Pre-Application Meeting (PRE20-037)

Site Location:	8817 SE 44 th ST		
Lot Size:	19,500 sf	Zoning:	R-9.6 (Single Family)
Brief Project Description:	Subdivide the existing lot into two lots. Demolish existing house and built 2 new homes.	Documents Provided:	Arborist report, plan set, pre-app form, project narrative, questions
Applicant Information:			
Name:	George Constantine	Email:	georgec@constantinebuilders.com
		Phone:	206-852-1740
Second Pre-application Meeting Required:	Not Applicable	Click for explanation if necessary

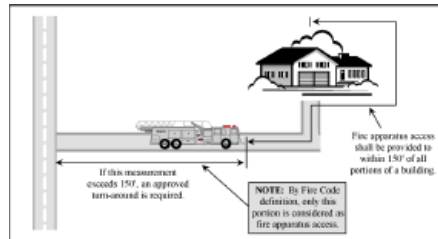
- a. "Shared Access Easement (Layout Option C); can we do this? width of easement? width of pavement? Setback from easement for Lot A?"
 - i. Shared access will need to conform with the minimum requirements of MICC if the driveway access is within 150' of the furthest point of the residence. If the access is further the driveway will need to be expanded to a minimum of 20' wide until that distance is met. See illustration below
